LiDAR Quality Assessment Report

SD_MORiver-Dewberry_2016-Block-5

Project: SD_MORiver-Dewberry_2016-Block-5

Vertical Accuracy Results:

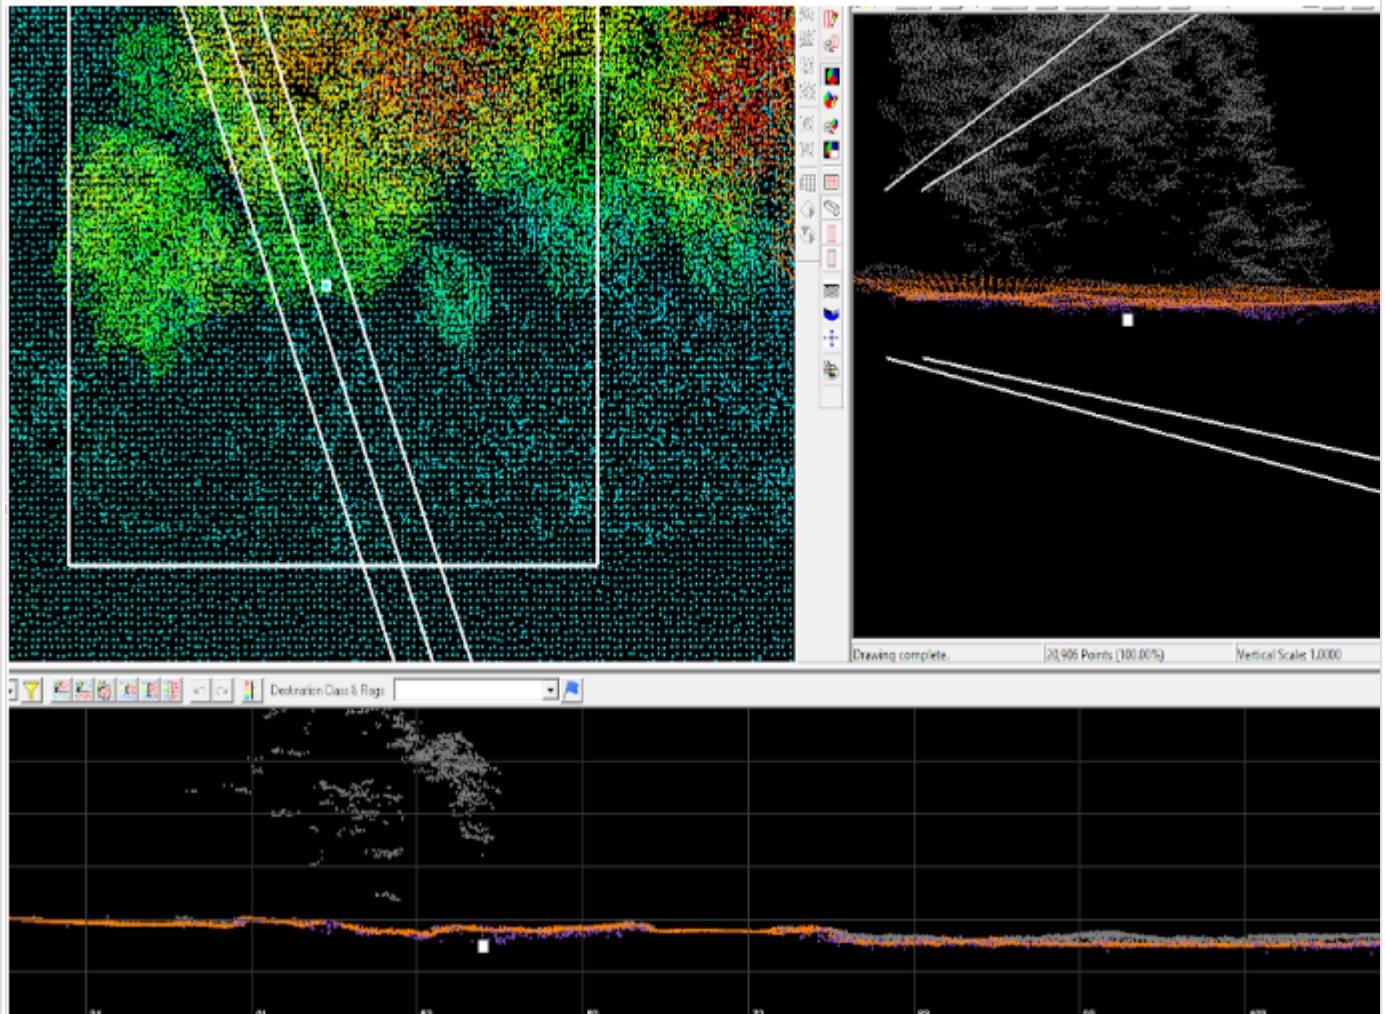
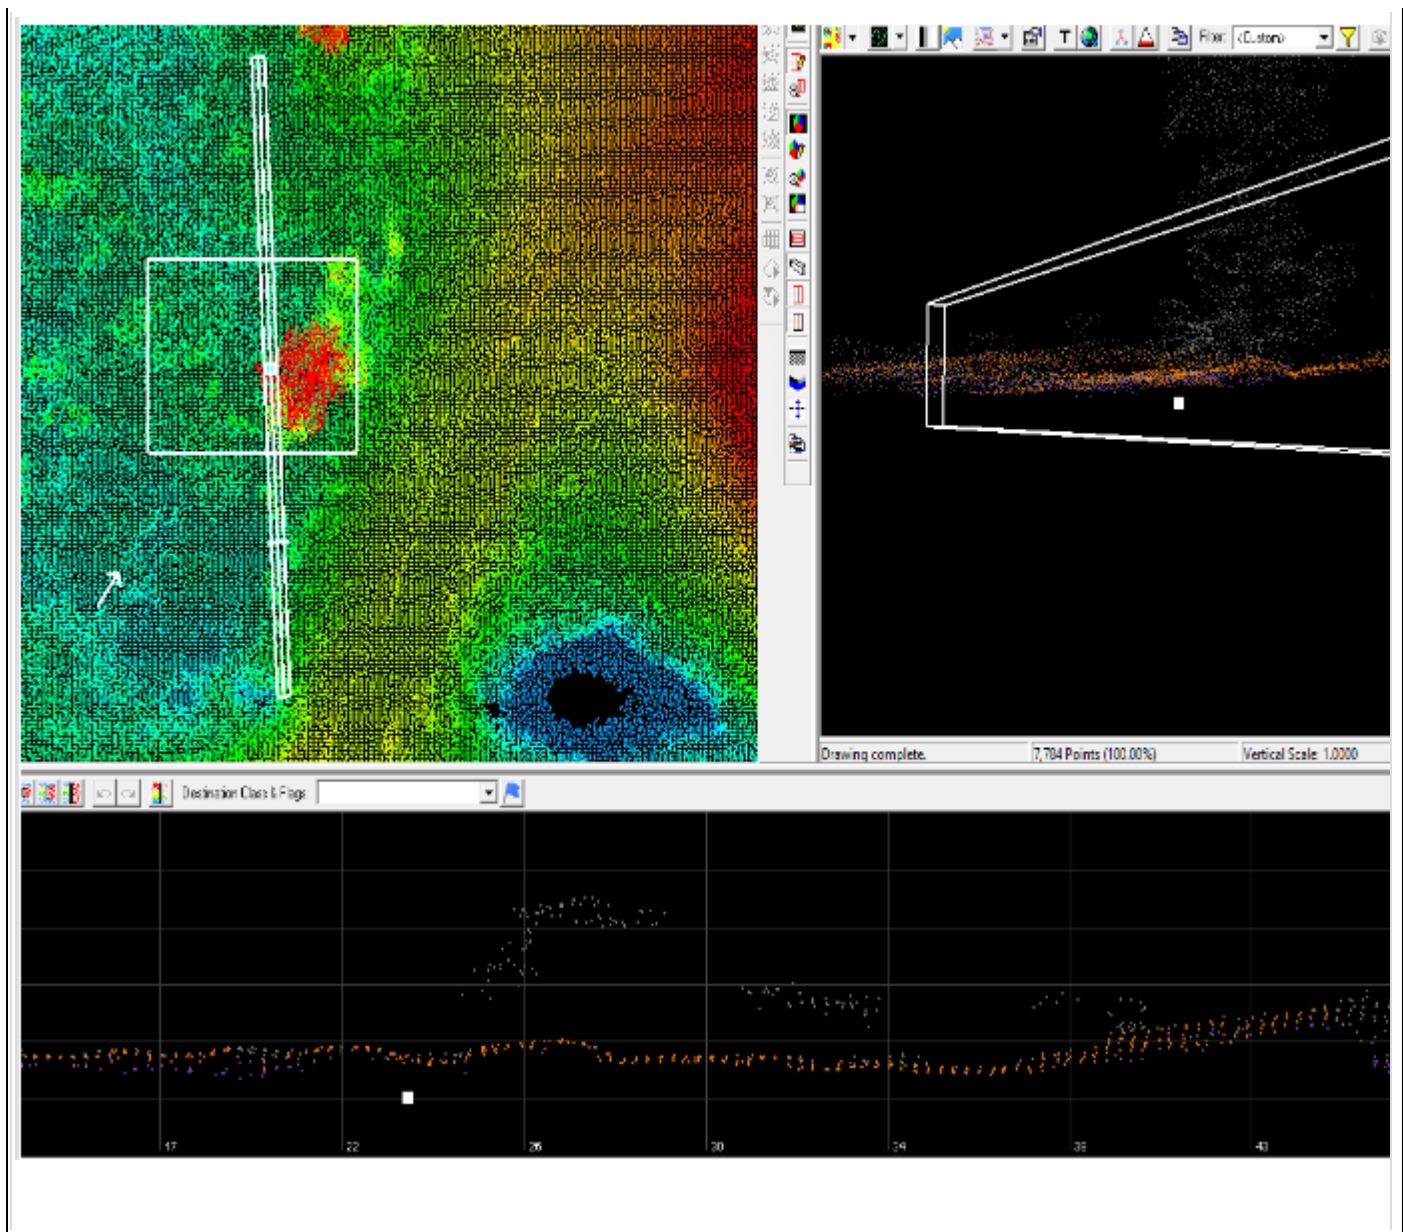
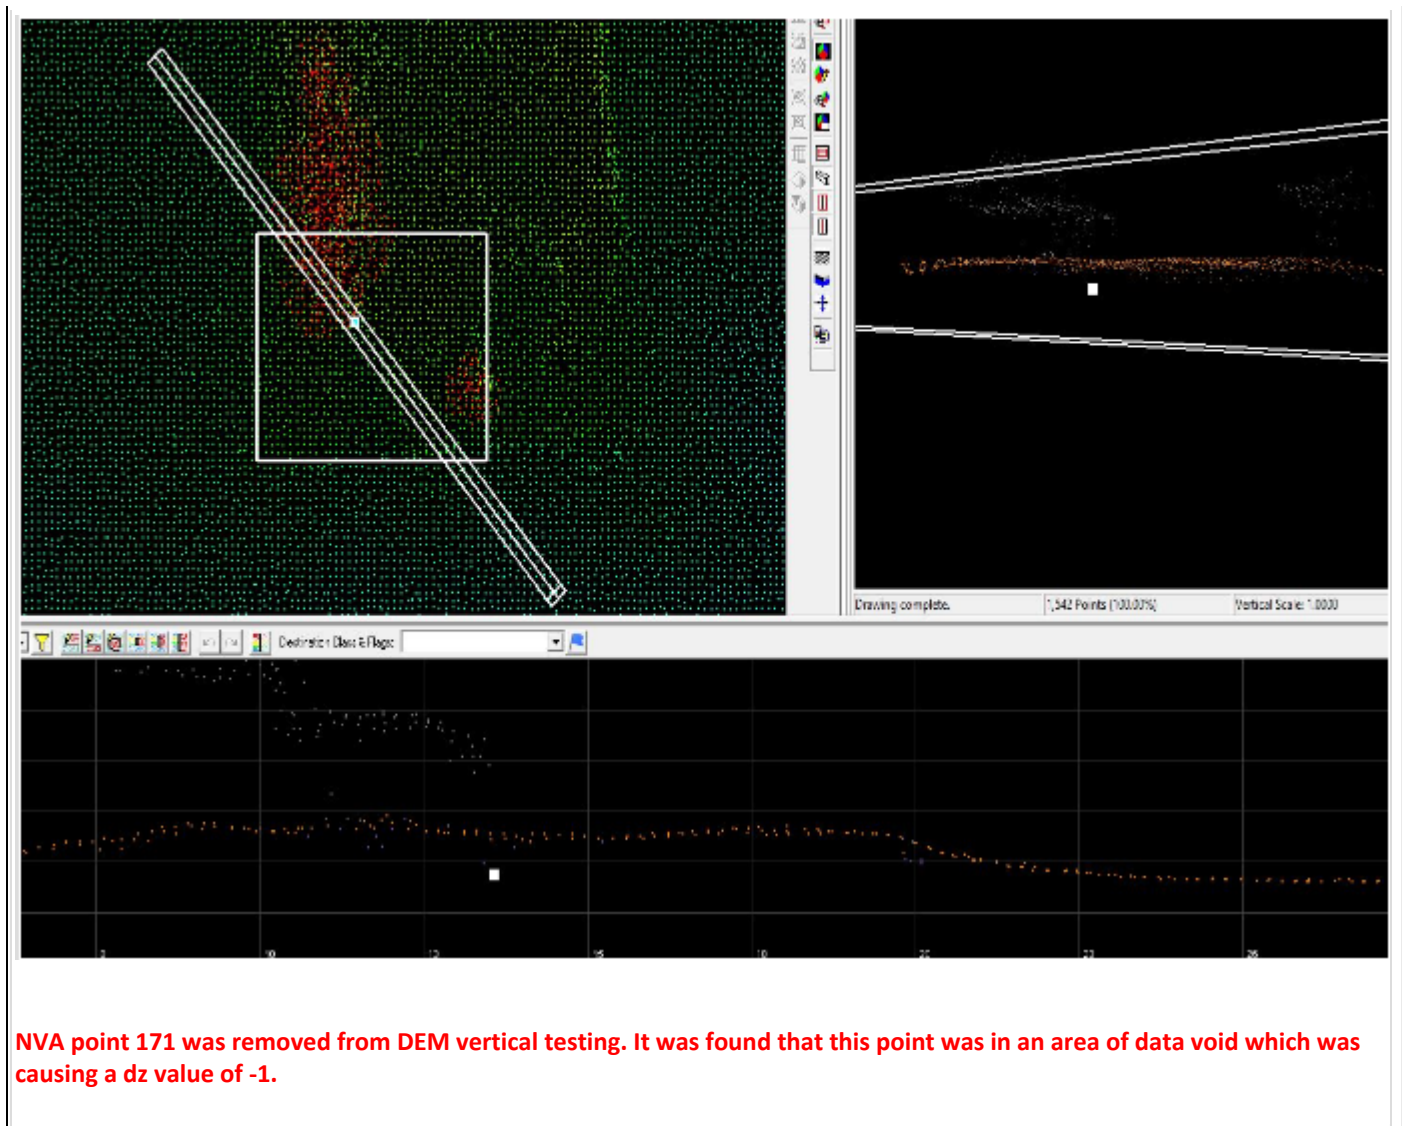
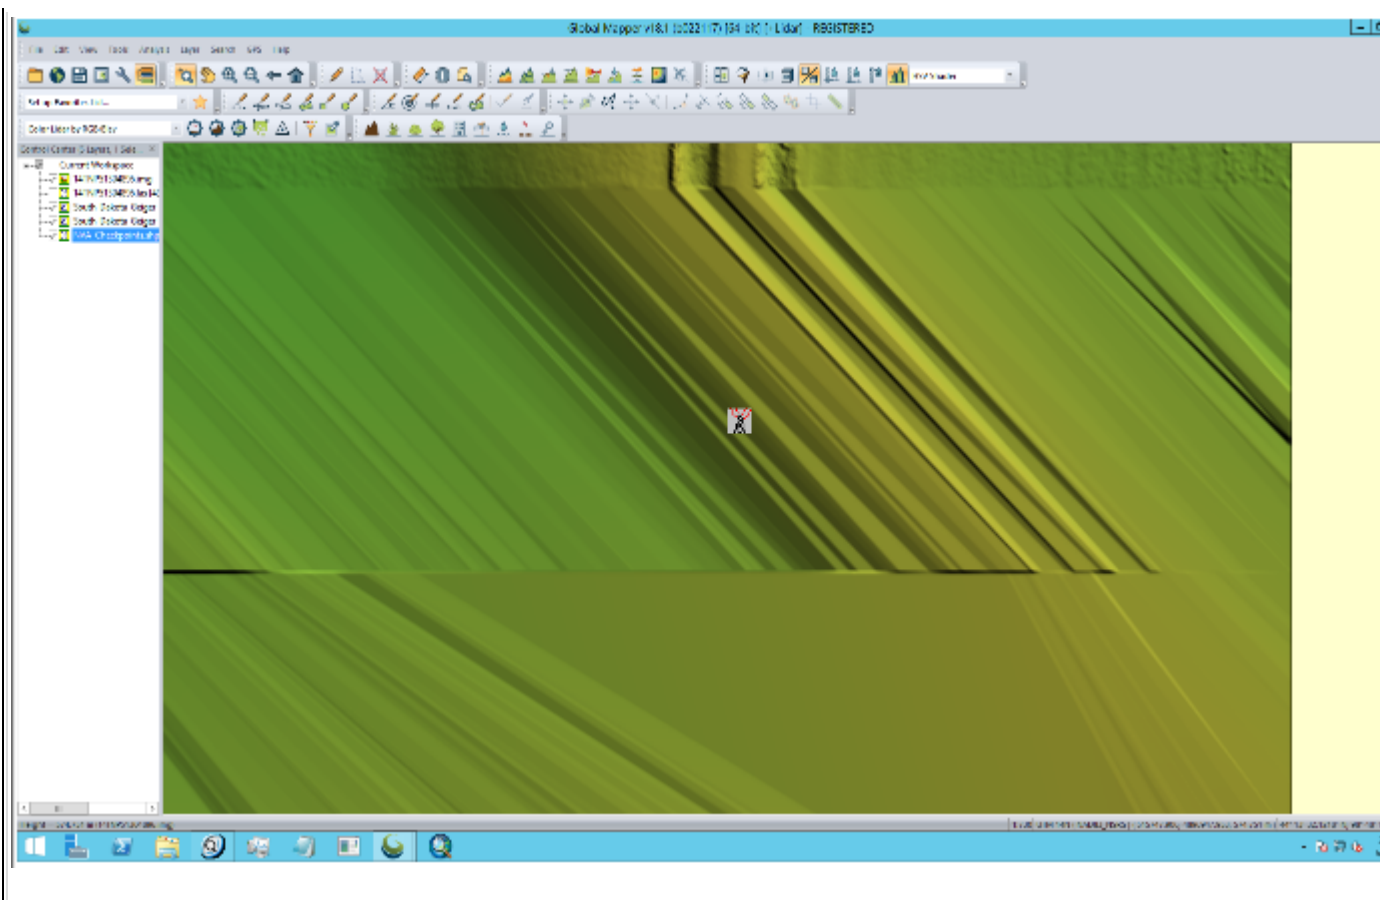
VVA testing failed to meet USGS specifications. Three of the worst points are pictured below, showing the checkpoint below the ground surface.

Based on this review, the USGS does not accept the vertical accuracy.

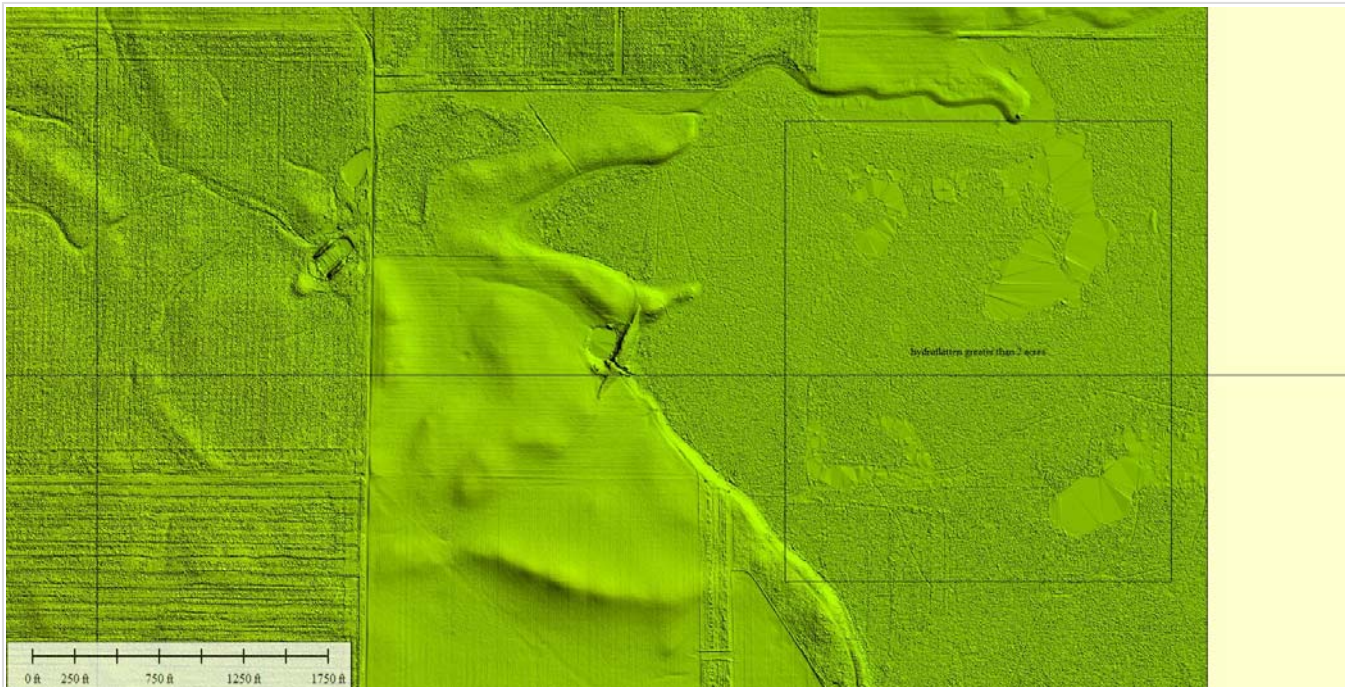
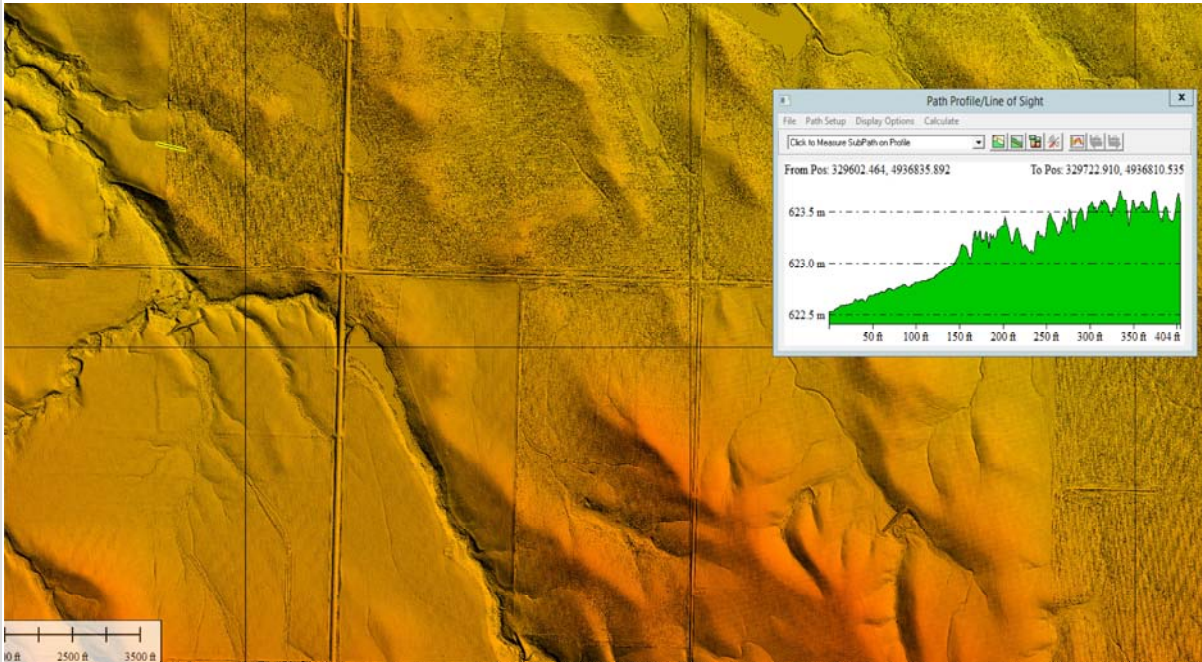
All through out block 5 there are areas of a possible classification issue: ground and low noise points in areas where there could be vegetation in fields.

Based on this review, the USGS does not accept the DEM tiles.
 End of DEM Review
